Ref. B2Gold Nunavut 2AM-BRP1831

Subject Landfarm Notification Memo – Responses to Supplemental Information Request

Interested Party:	Crown Indigenous & Northern Affairs Canada (CIRNAC)	TRC NO.:	CIRNAC-R-01
Re:	B2Gold Nunavut – Goose Mine – Landfarm: Erosion and Sediment Control Measures

**B2GOLD CORP.
GOOSE LAKE LAND FARM
BACK RIVER, NUNAVUT
ISSUED FOR PERMIT
APRIL 22, 2026**

Drawing No.
2500548-C1.1

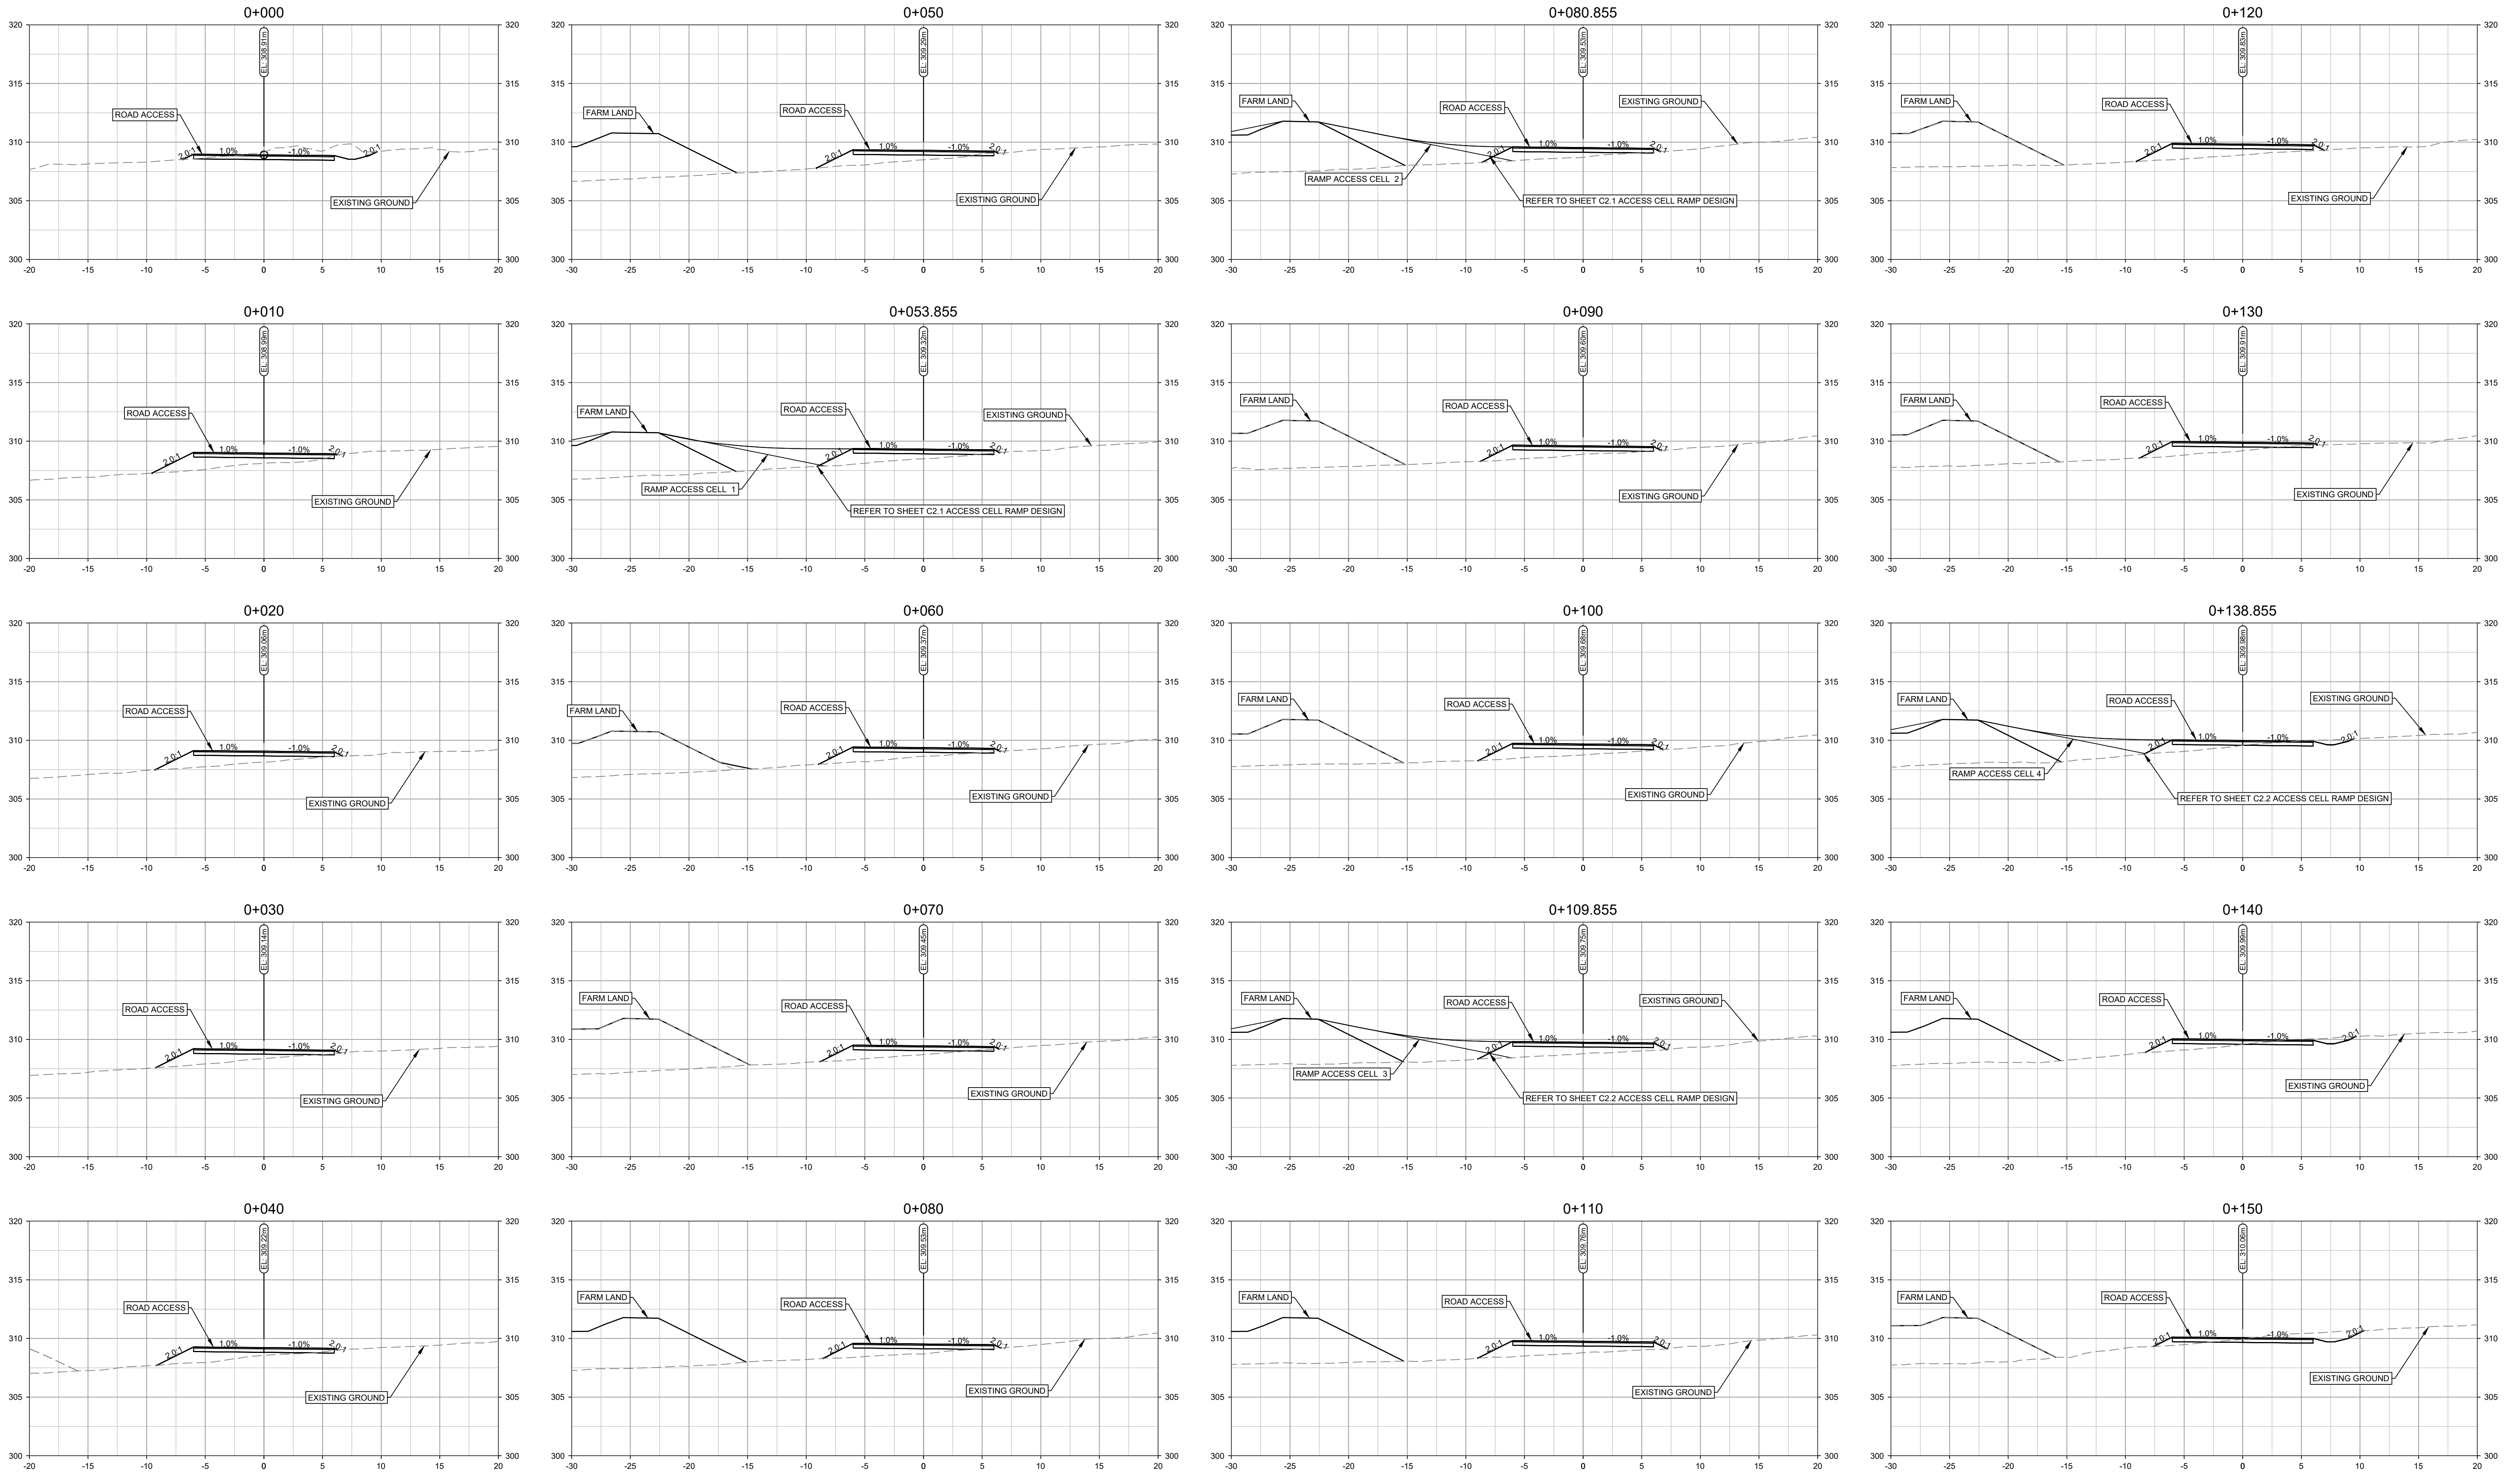
Access roads are mentioned in section 5.2.1 but are not mentioned or defined in any other section. CIRNAC is concerned access roads will be necessary to carry out the construction and operation of the Facility.

(R-03) CIRNAC recommends that B2Gold clarify whether the access roads will be included in this application or an additional one. Additionally, for either case, CIRNAC recommends the access roads be described and shown in the plan with dimensions.

- The Landfarm will be accessed via an existing all-weather site road and a new access road, which will form part of a pad expansion, will be constructed to gain access to the cells. The “pad expansion” is part of a separate submission for a new Waste Management Facility.
- The existing access road is constructed of crushed non-acid generating rock material. The segment adjacent to the Landfarm is shown in the updated drawing (Appendix A).
- While this area will eventually be integrated into a larger, future Waste Management Facility (currently under design for a separate submission to the NWB), the current Landfarm operations will utilize the existing road network.

Please refer to the drawing (Appendix A) which includes the access road dimensions and location relative to the Landfarm footprint.
